PROPOSAL FOR DRAFT AMENDMENT TO REGULATION No. 30

(Pneumatic tyres)

Transmitted by the experts from Japan

Note: The text reproduced below has been prepared by the experts from Japan in order to introduce requirements and a test procedure for type approval of "Run Flat System" operating in "Flat tyre running mode", while considering a standardized protocol (based on a draft ISO 16992).

Insert a new paragraph 3.1.12., to read:

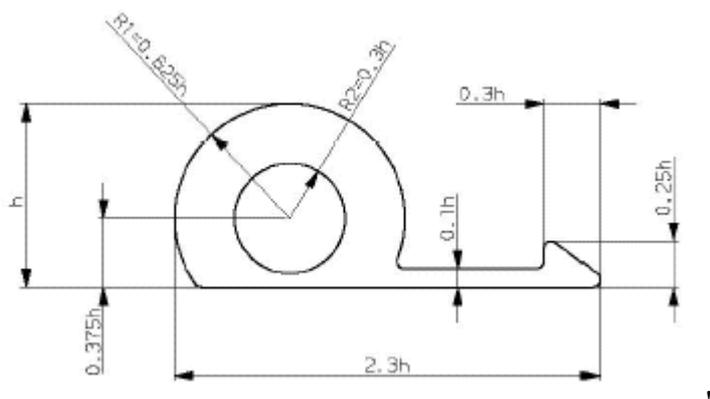
"3.1.12. The symbol below if the tyre is a "run flat" or "self supporting" tyre, where "h" is at least 12 mm.
